DIVISION OF ENGINEERING SERVICES
GEOTECHNICAL SERVICES

Retaining Wall & KP 11.3

Subject : Slide Repair Foundation Recommendations

Subject: Corrosion Review for Route 116 Slide Repair

Figure 1 - Pressure Diagram

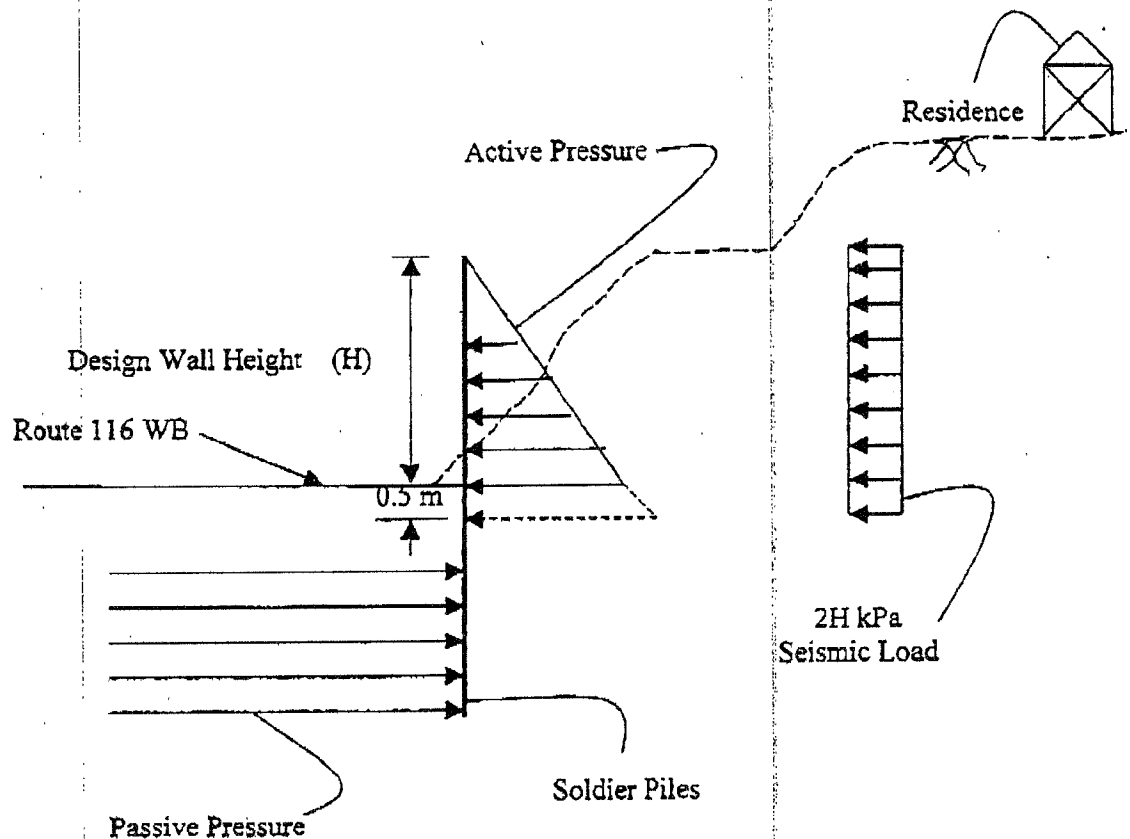
- a. A triangular pressure diagram from the top of the wall to about 0.5 m below the dredge line of the wall as shown on Figure 1 below. Use an equivalent fluid pressure of 5.5 kN/m^3 per 0.3 m of depth (based on an internal friction angle $\phi = 34^\circ$ for the structure backfill behind the wall with unit weight $(\gamma) = 18.85 \text{ kN/m}^3$ (120 pcf).
- b. A uniform pressure diagram of $2H \text{ kPa}$ for seismic loading assuming an average horizontal acceleration of $0.5g$. See Figure 1 below.

EXHIBIT A

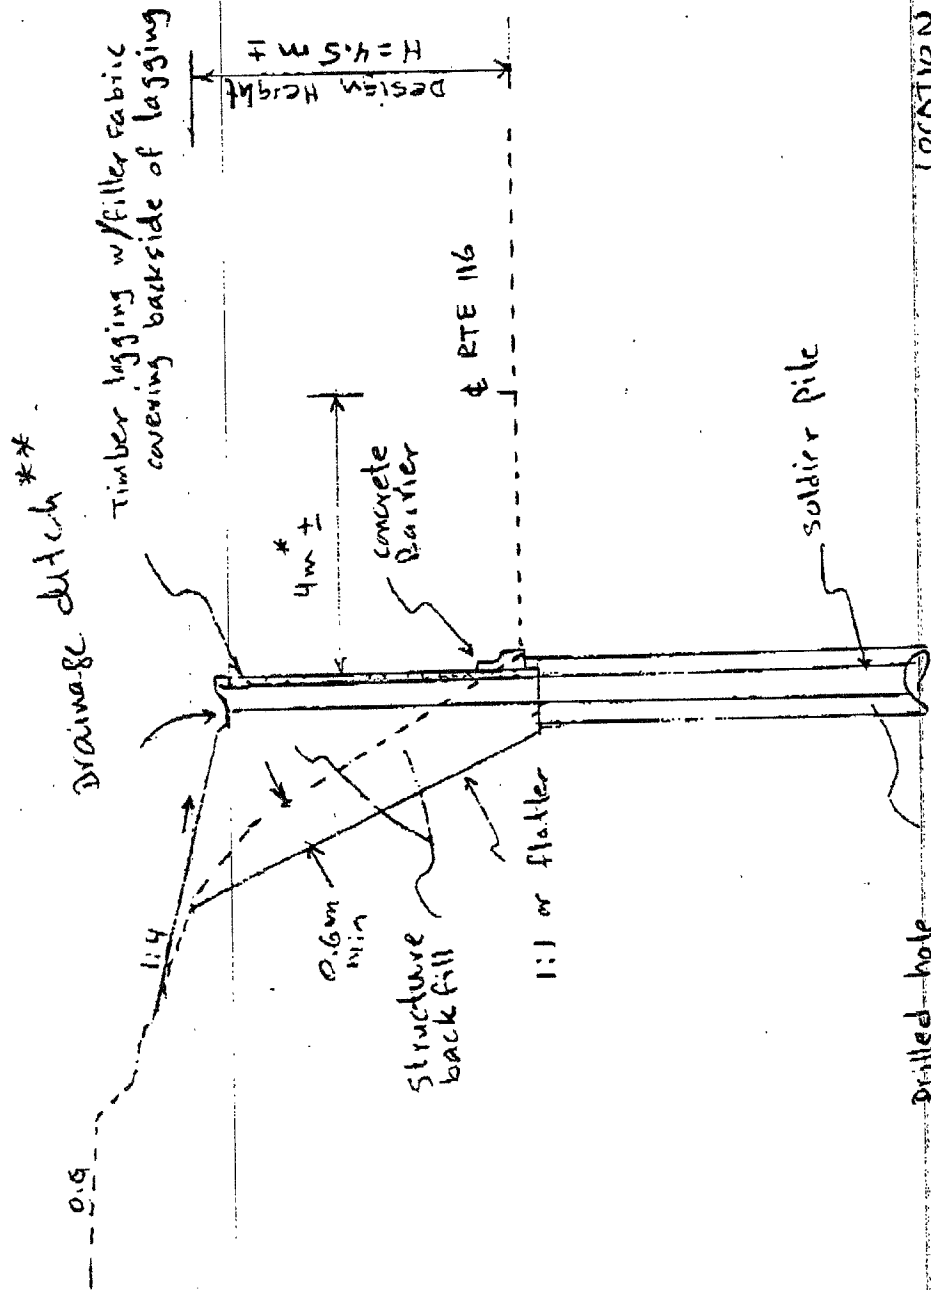
However, to minimize the impact of the project on the adjacent private property and because of right of way constraint, ease of construction, and cost effectiveness, we recommend a soldier pile wall with wood lagging to repair the slipout. Due to the close proximity of the wall to the traffic, a concrete barrier should be installed at the base of the proposed wall. See attached Exhibit A.

- b. For design purposes, consider level ground condition in front of the wall and 1:4 sloping ground conditions with a slope of 1V:4H above the wall as shown on the attached Exhibit A.

- To remove the failed portion of the slipout (slough), excavate into the cut slope behind the proposed wall by at least 0.6 m and replace with structure backfill as shown on the attached Exhibit A. During construction, if the depth of the slough is determined by the Engineer to be more than 0.6 m, the depth of the excavation should be increased accordingly.
